DeltaPSU 产品公告

CliQ M DC-UPS 模块产品变更通知

台达 CliQ M DC-UPS 模块的缓冲时间将从“2 分钟”修改为“30 分钟”。

变更内容:

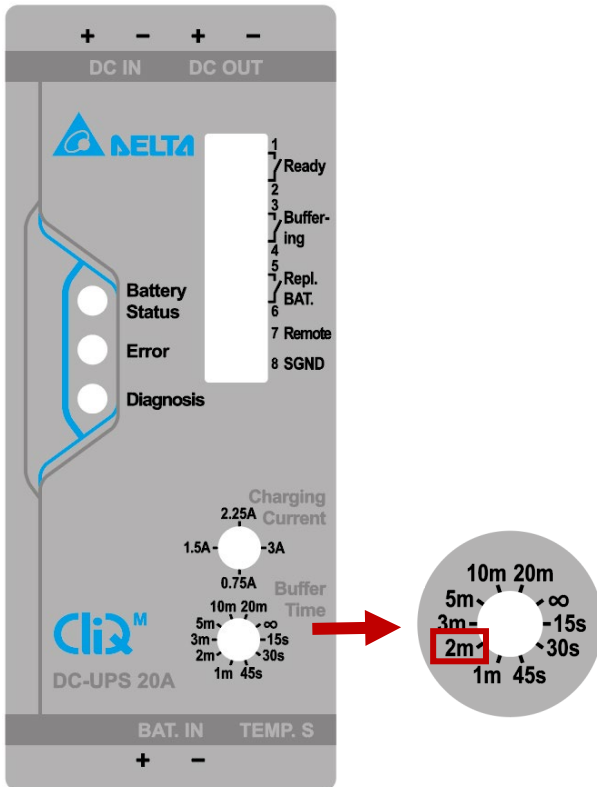
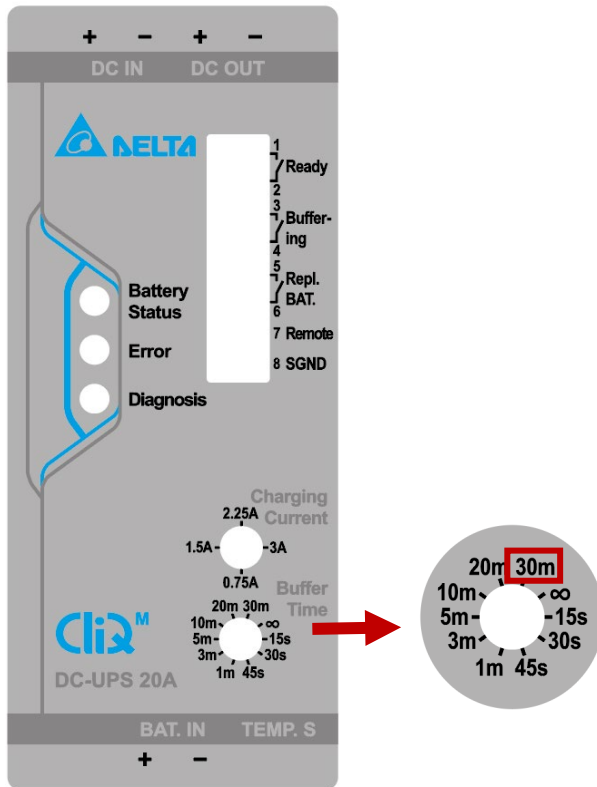
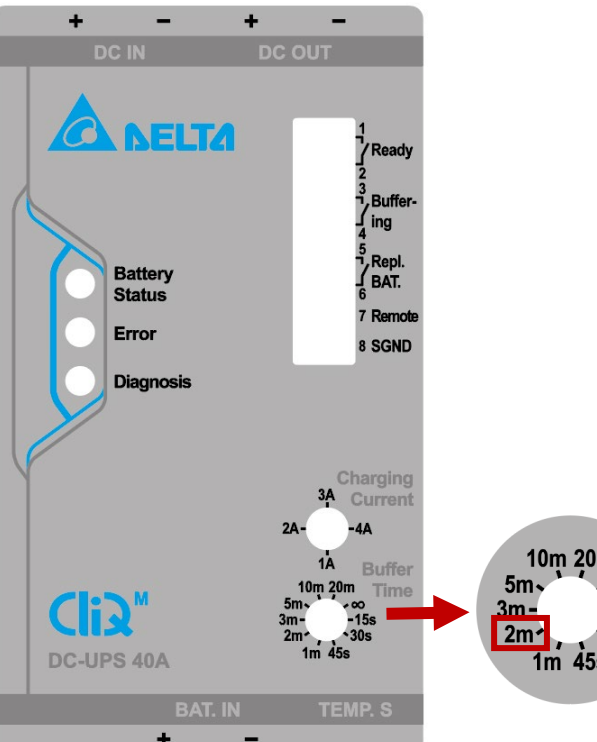
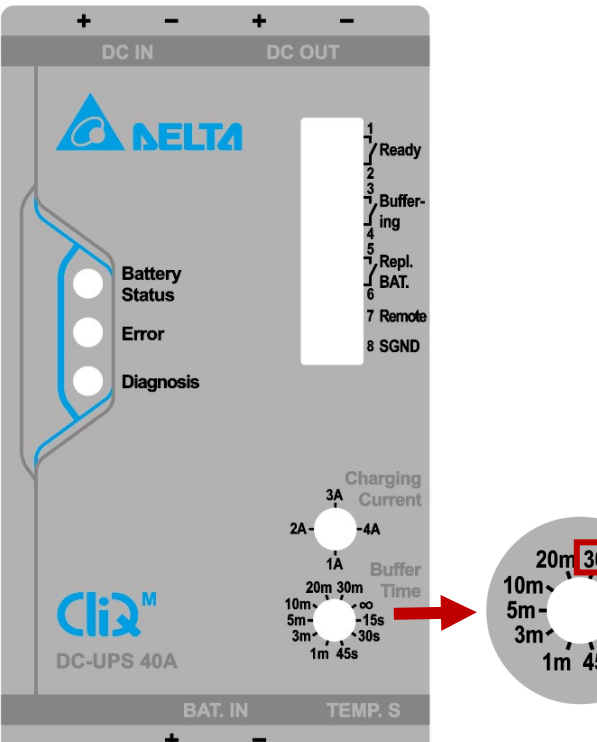
变更前	变更后
<p>DRU-24V20AMN</p>  <p>Charging Current: 1.5A, 2.25A, 3A Buffer Time: 5m, 10m, 20m, 3m, 15s, 2m, 30s, 1m, 45s</p>	<p>DRU-24V20AMN</p>  <p>Charging Current: 1.5A, 2.25A, 3A Buffer Time: 10m, 20m, 30m, 5m, 15s, 3m, 30s, 1m, 45s</p>
<p>DRU-24V40AMN</p>  <p>Charging Current: 2A, 3A, 4A Buffer Time: 5m, 10m, 20m, 3m, 15s, 2m, 30s, 1m, 45s</p>	<p>DRU-24V40AMN</p>  <p>Charging Current: 2A, 3A, 4A Buffer Time: 10m, 20m, 30m, 5m, 15s, 3m, 30s, 1m, 45s</p>
